**MANDATORY**  
**SERVICE BULLETIN**

Service Bulletin No. 543A  
(Supersedes Service Bulletin No. 543)  
Engineering Aspects are  
FAA Approved

SUBJECT: Oil Filter Converter Plate Gasket Replacement

Figure 1

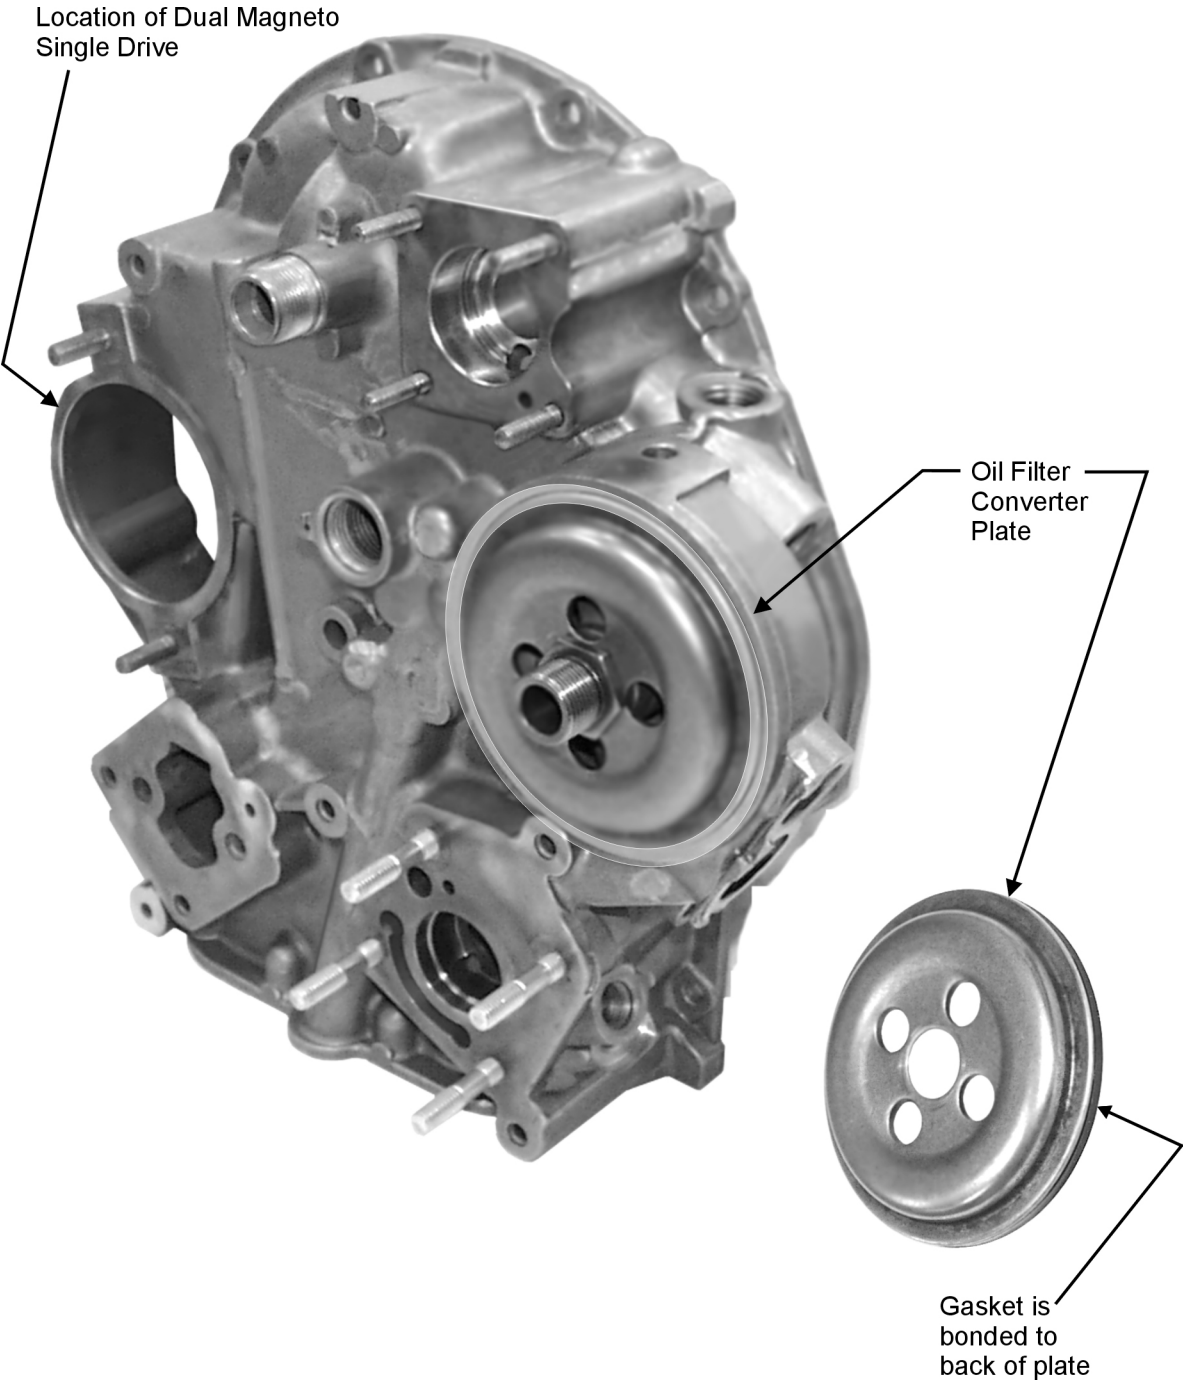
Textron Lycoming has received reports indicating that operation at high oil temperatures can cause the converter plate gasket on the oil filter base to become extruded from its seat, allowing oil to leak out between the plate and the accessory housing.

1. Remove the oil filter and the converter plate (Figure 1). Remove the gasket from the plate in accordance with Textron Lycoming Service Instruction No. 1453.
2. Replace the gasket with a new gasket P/N LW-13388. Bond the gasket in place and reinstall plate per Textron Lycoming Service Instruction No. 1453. Reinstall oil filter.
3. Make appropriate logbook entry of compliance.
4. Replace this gasket at every 50 hour oil change thereafter per this Service Bulletin.
